FORD E4OD "UPDATE HANDBOOK"

*Updated
April, 2004*

VALVE BODY, SPACER PLATE, SPACER PLATE GASKETS, CHECKBALL LOCATIONS, AND CASE CHANGES, FOR THE 1996 MODEL YEAR

Figure 44
 AUTOMATIC TRANSMISSION SERVICE GROUP

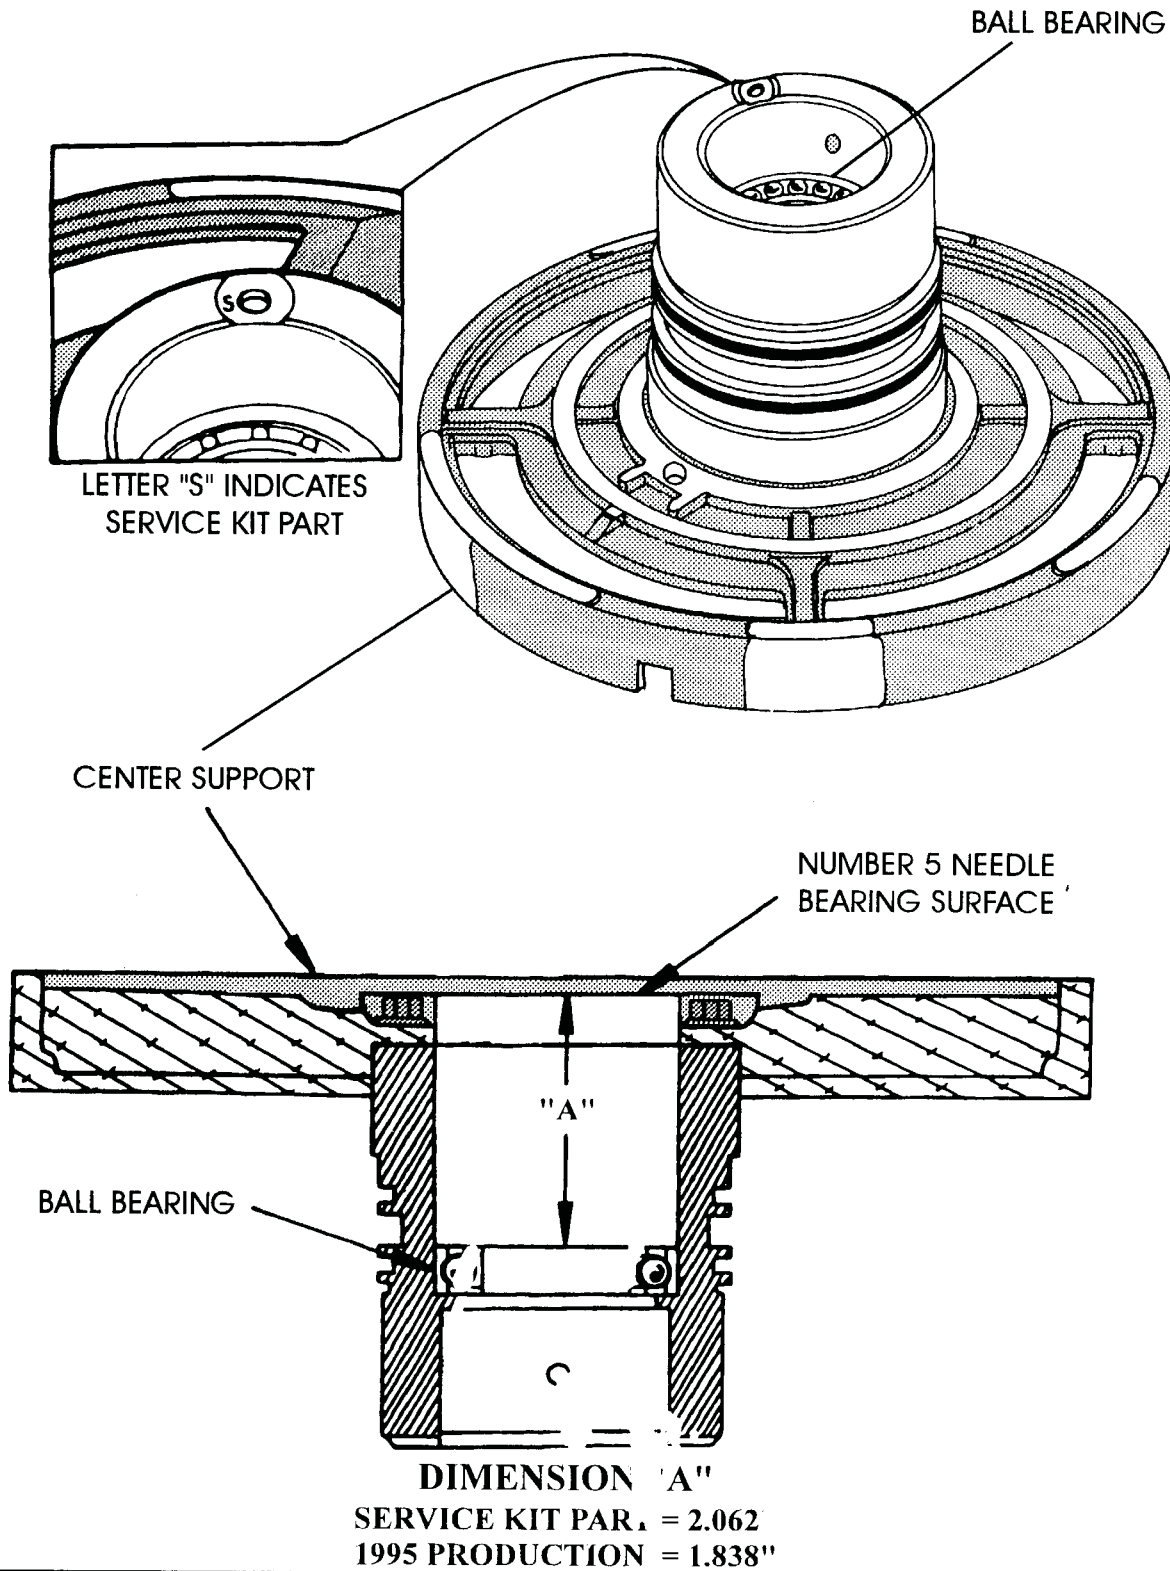
- (1) **CENTER SUPPORT** - Different machining dimensions on the inside bore, to accommodate an added ball bearing that will now support the overdrive center shaft. The new design ball bearing support can be identified as a "Service Part", by the letter "S" stamped on hub, in the location shown in Figure 44. The Service Kit Ball Bearing Center Support has different dimensions than the 1995 production ball bearing center support. Refer to Dimension "A" on the cutaway drawing shown in Figure 44.

Figure 47
AUTOMATIC TRANSMISSION SERVICE GROUP

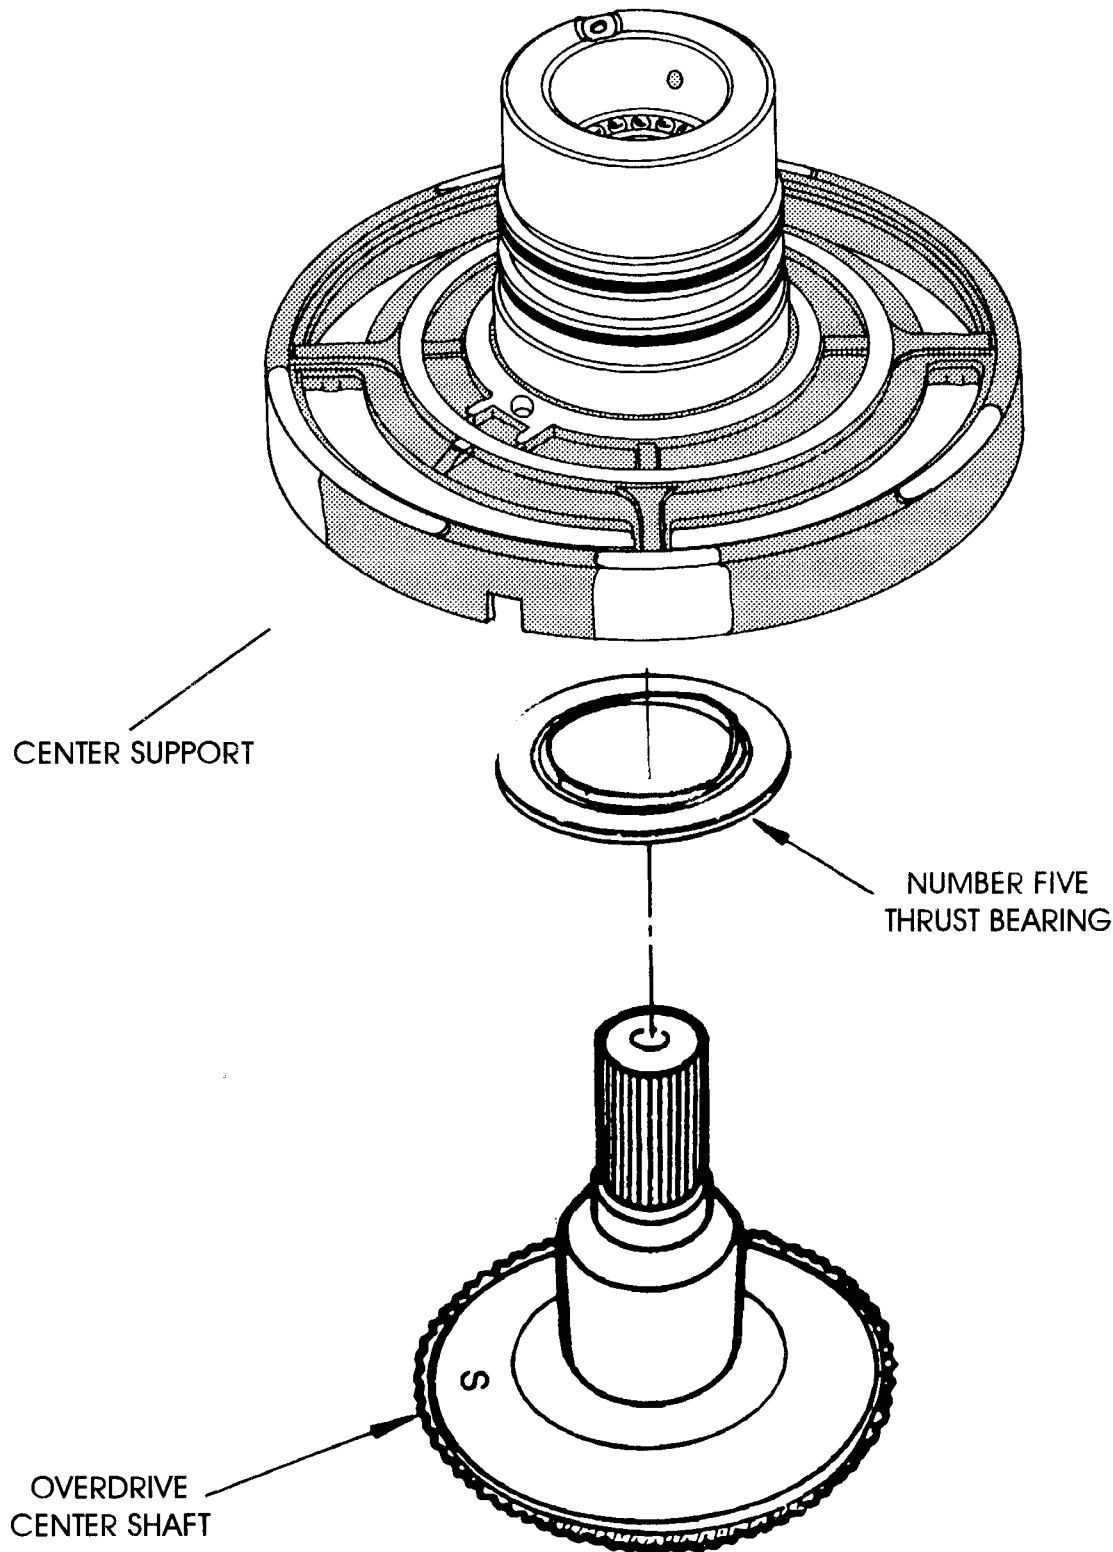
- (4) NO. 5 NEEDLE BEARING - Make certain the No. 5 Needle Bearing included in the service kit is installed with the service kit *regardless* of whether your unit had one or did not have one. Some 1994 model year transmissions were built with some or all of the parts that "Resemble" the parts in this service kit, and may or may not have a No. 5 needle bearing. Make certain that the No. 5 needle bearing from the service kit is installed. Refer to Figure 47 for proper installation of the needle bearing.

Figure 48
AUTOMATIC TRANSMISSION SERVICE GROUP

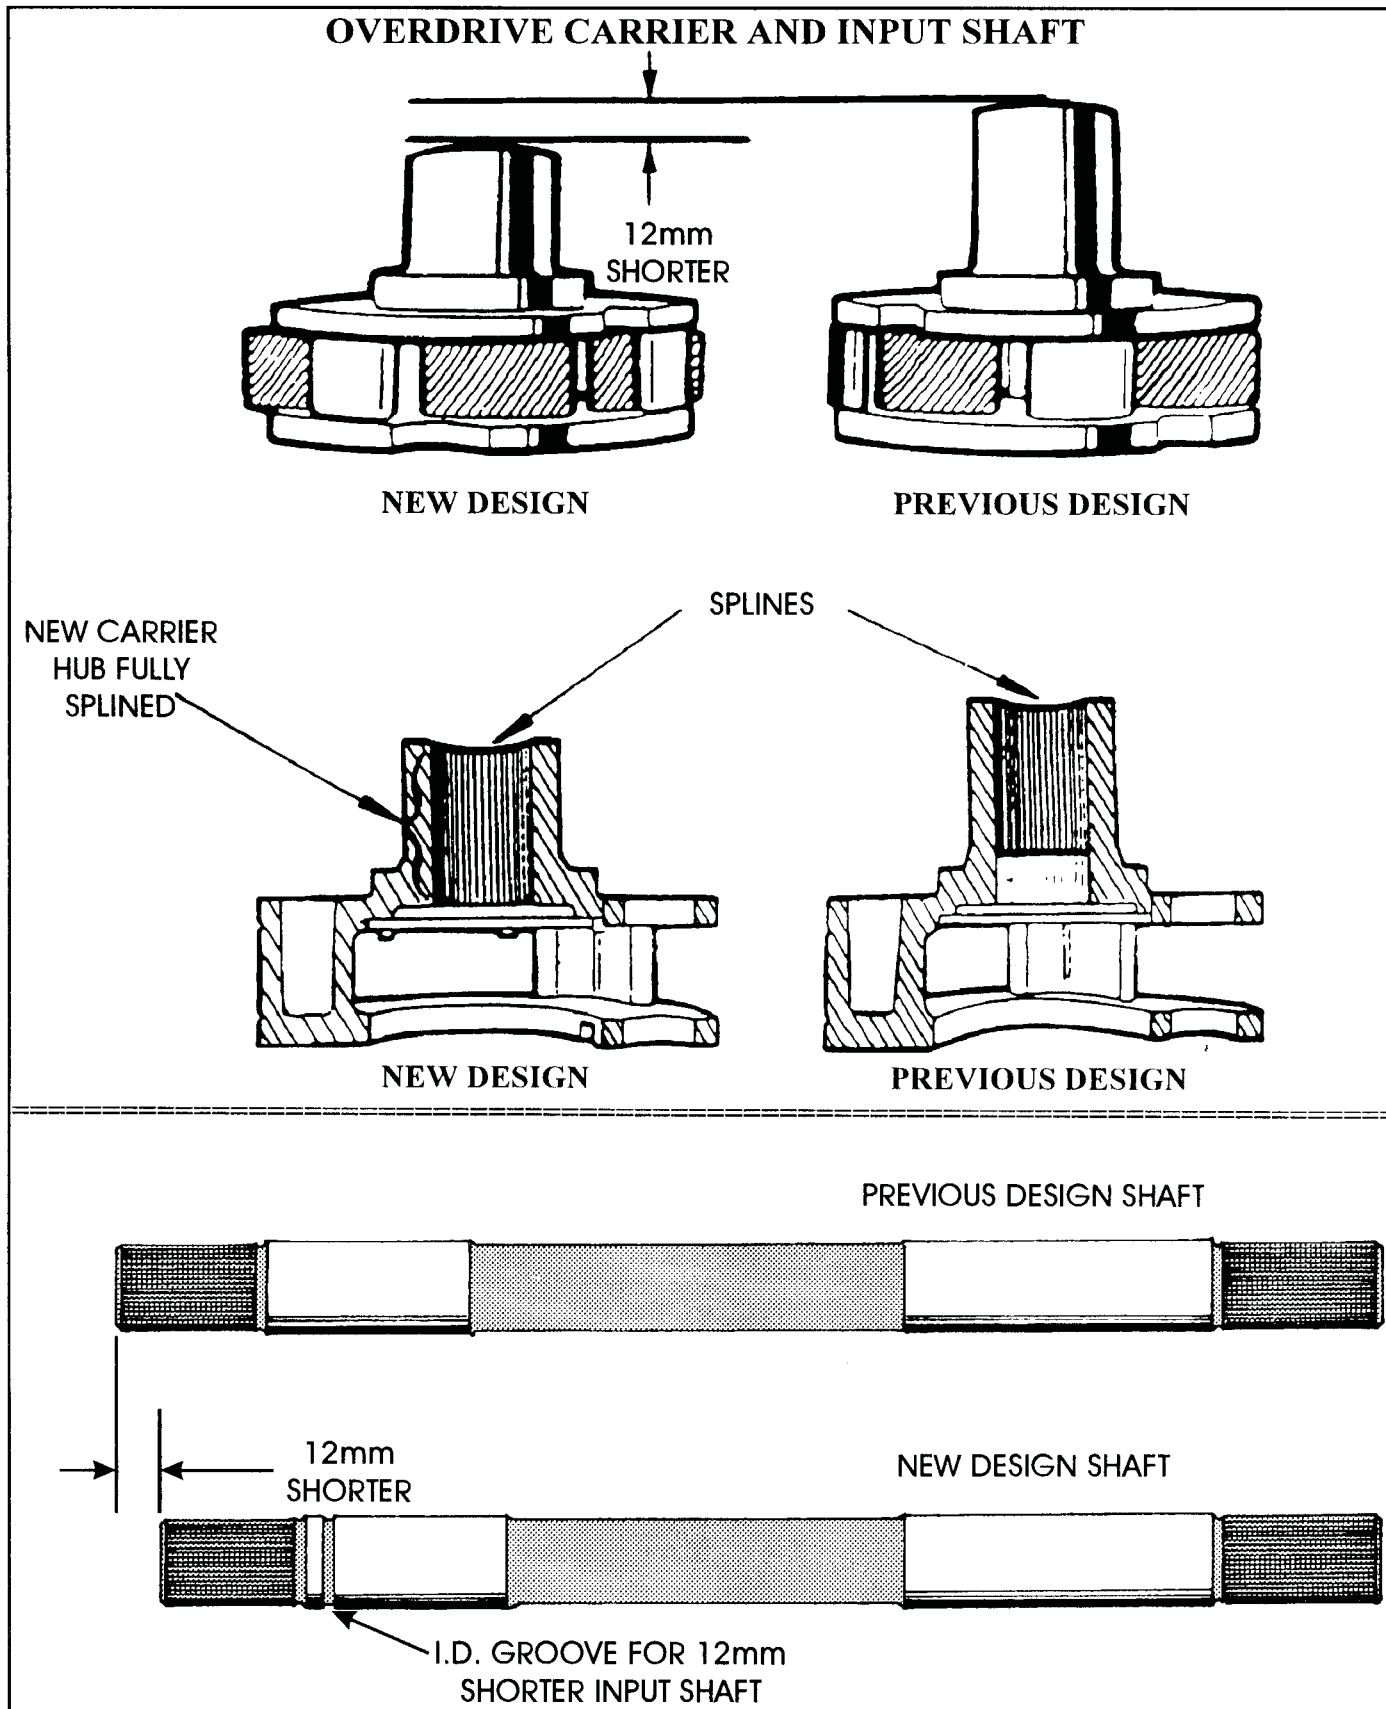
- (2) **OVERDRIVE CENTER SHAFT** - Different machining dimensions on the center shaft to accommodate the added ball bearing, and the pilot on the center shaft has been removed. The new design Overdrive Center Shaft can be identified as a "Service Part", by the letter "S" stamped on the shaft in one of two locations, as shown in Figure 45. The Service Kit Overdrive Center Shaft has different dimensions than 1995 model year production center shaft. Refer to Dimensions "A" and "B" in the cutaway drawing shown in Figure 45.
Special Note: There is also an updated Overdrive Carrier and Input Shaft, available under OEM part number F4TZ-7B446-B, to help improve durability. Both pieces have different dimensions than the previous parts, as shown in Figure 48. The new overdrive carrier hub is 12mm (.472") shorter than the previous models, and the internal splines now run the full length of the hub which makes it stronger. The Input Shaft is also 12mm (.472") shorter than the previous models, to accommodate the new overdrive carrier, and has an I.D. groove cut in the shaft for identification (See Figure 48).

Figure 52

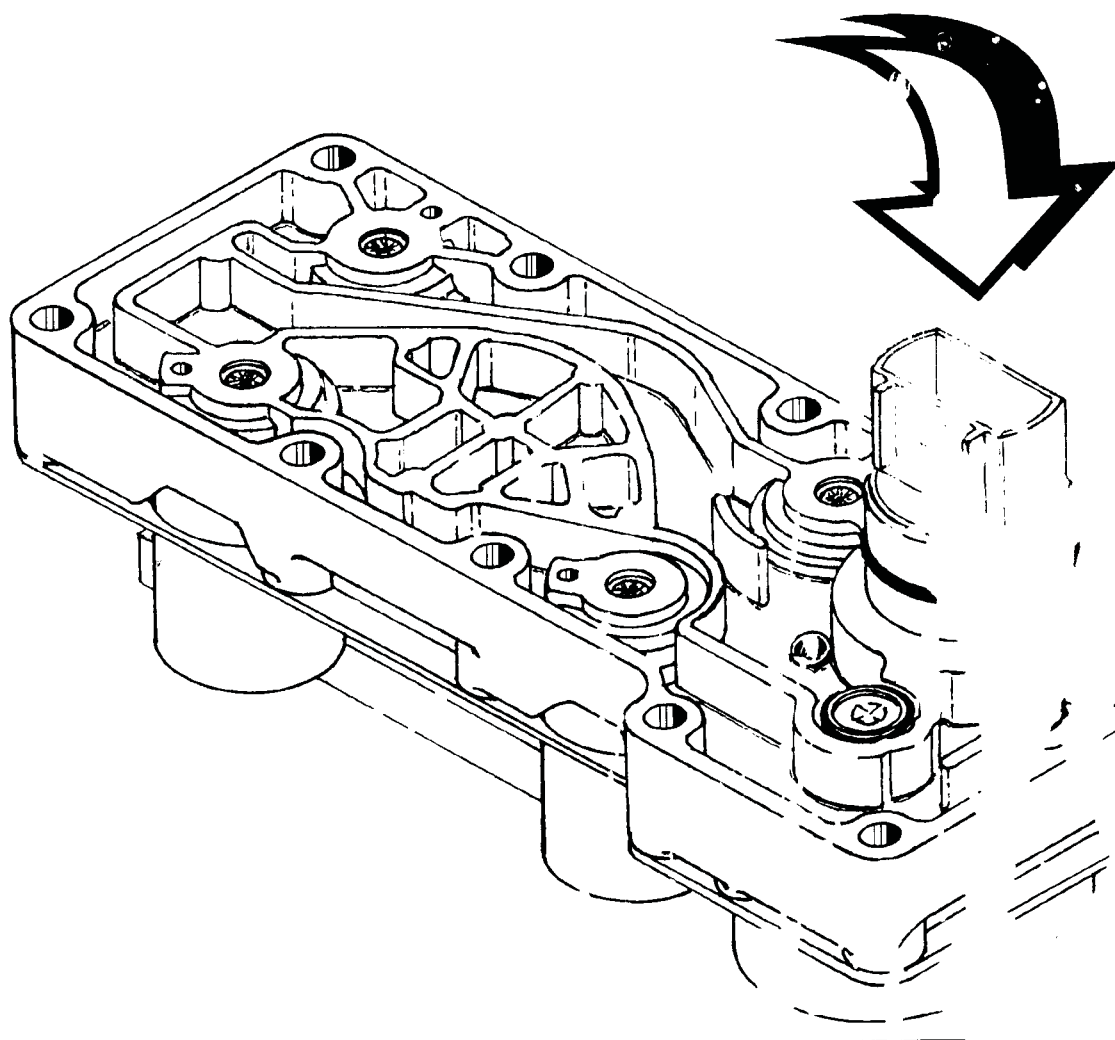
- (1) **SOLENOID PACK** - New design solenoid assembly case connector to accommodate the new design vehicle harness connector. Refer to Figure 52 for identification of the previous design and the new design solenoid assemblies.

NOTE: The plastic sleeve incorporated in the previous design solenoid pack has been eliminated on the new design solenoid pack (See Figures 52 and 53). This plastic sleeve will sometimes remain on the vehicle harness connector when it is disconnected. If a new solenoid pack is installed (which includes sleeve), it will be impossible to reconnect the vehicle harness to the solenoid pack until the old sleeve is removed from vehicle harness connector. Refer to Figure 53.

Figure 54

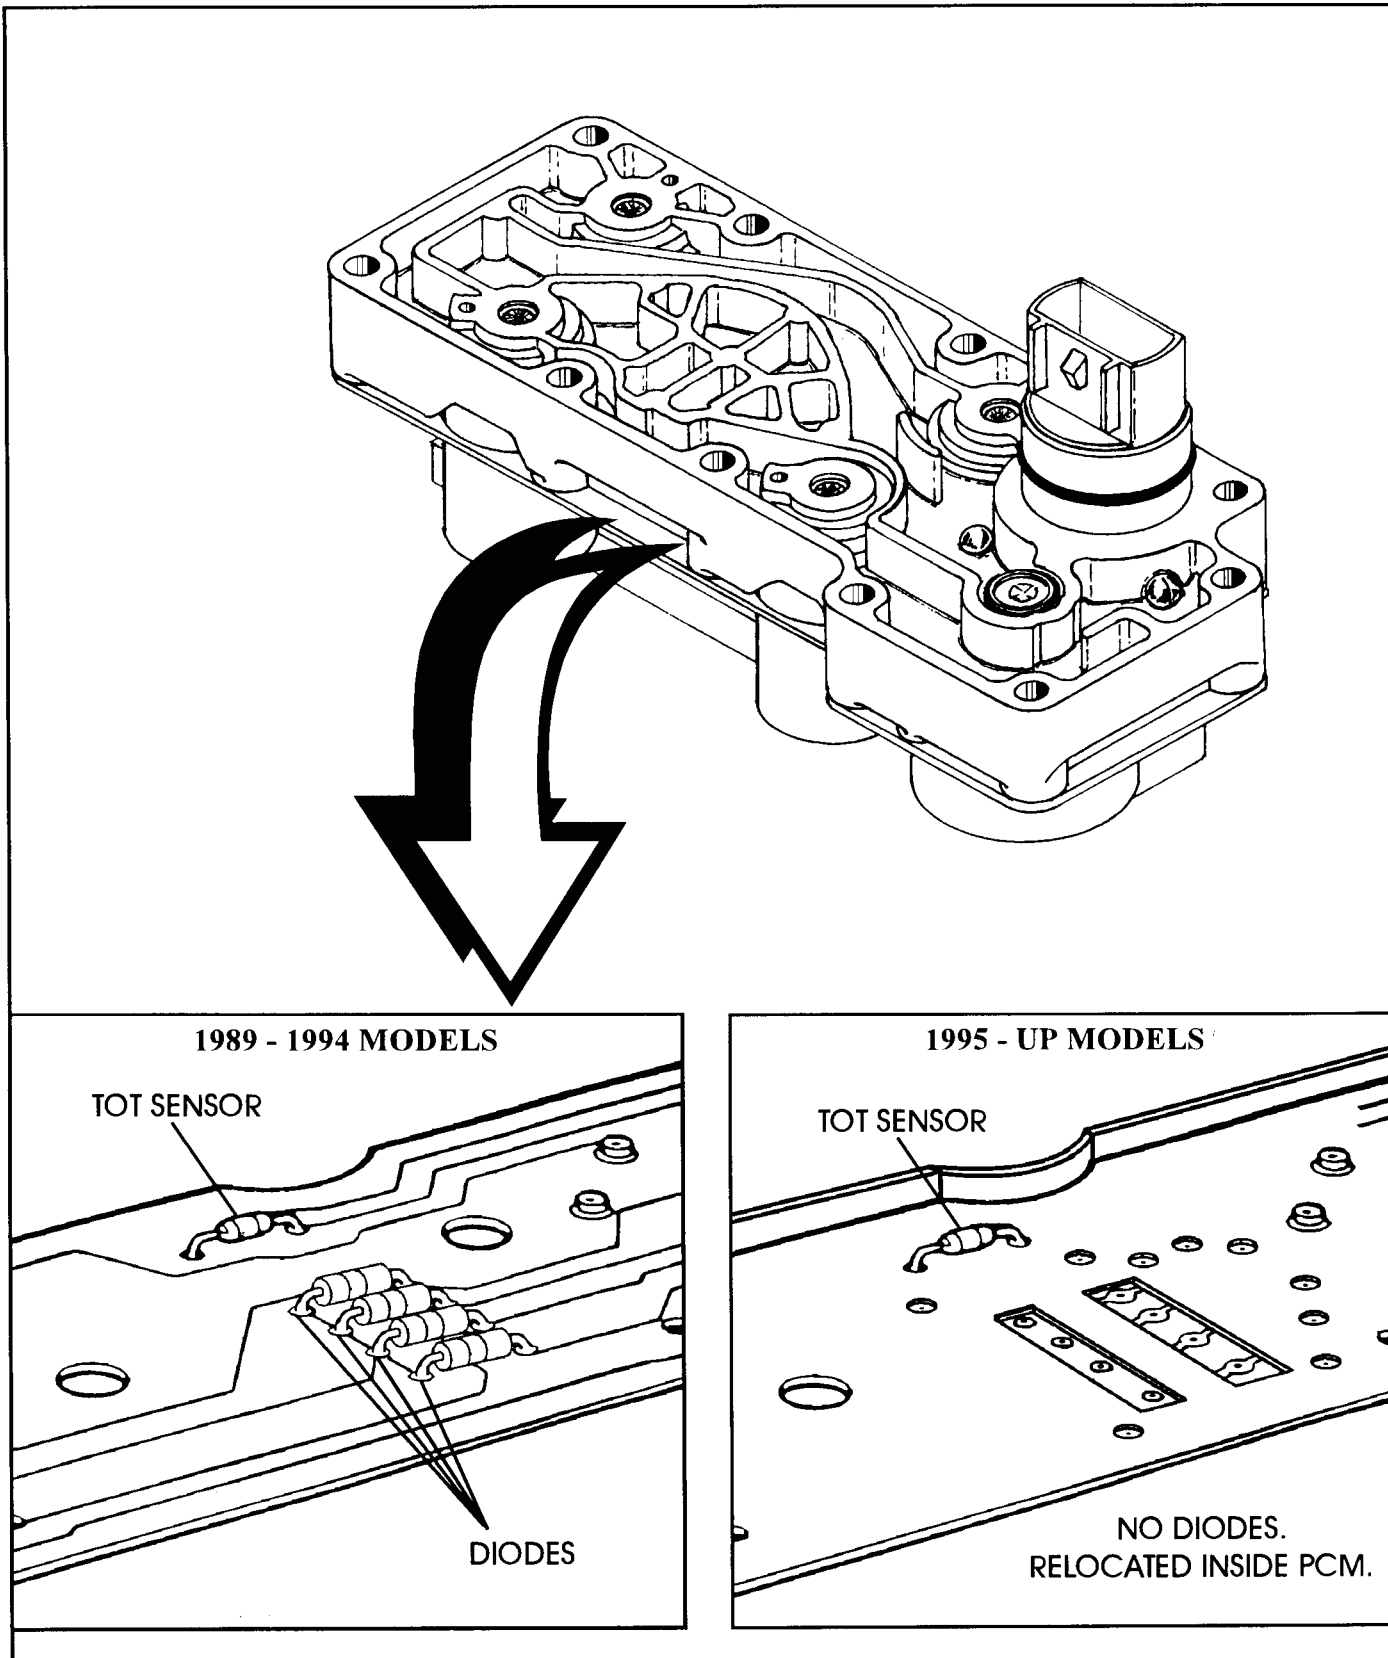
CHANGE: Beginning at the start of production for 1995, all models of the E4OD transmission were produced using a new design solenoid pack, that will not interchange with previous models, as the internal diodes have been eliminated and put into the PCM (See Figure 54)

They will not interchange because in 1995 models the diodes for the solenoids were moved out of the solenoid pack and placed into the PCM (See Figure 54).
